ABB MEASUREMENT & ANALYTICS | RELEASE NOTES

# **Embedded software 2108315**

## **Flow computer ( $\mu$ FLO<sup>G5</sup>)**

MARCH 5, 2024

**Figure 9-1: Board number label on  $\mu$ Flo<sup>G5</sup> electronic board**

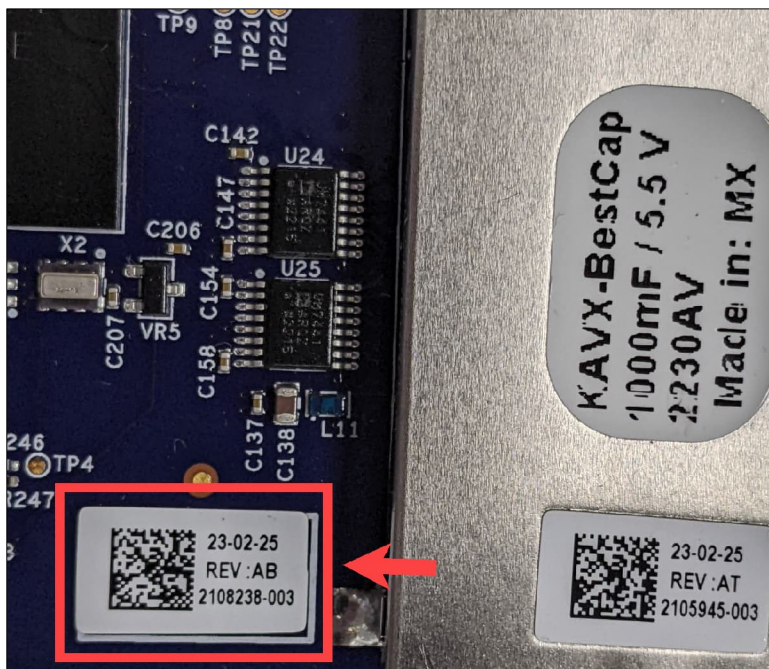
**i** **IMPORTANT NOTE:** Customer package part number 2108315 replaces previous part number 2105409 and is compatible with all previous  $\mu$ FLO<sup>G5</sup> hardware versions. The previous customer package part number 2105409 has been withdrawn (it does not support board number 2108238 shown in [Figure 9-1](#)).

Devices with customer package part number 2108315 and with board part number (2108238 or later) do not display the correct board number in the PCCU **Registry** tab. The previous board number is hard coded in the software and does not update when the board number is different. To obtain the correct board number, access the board inside of the enclosure, visually inspect the board and locate the sticker with the information.
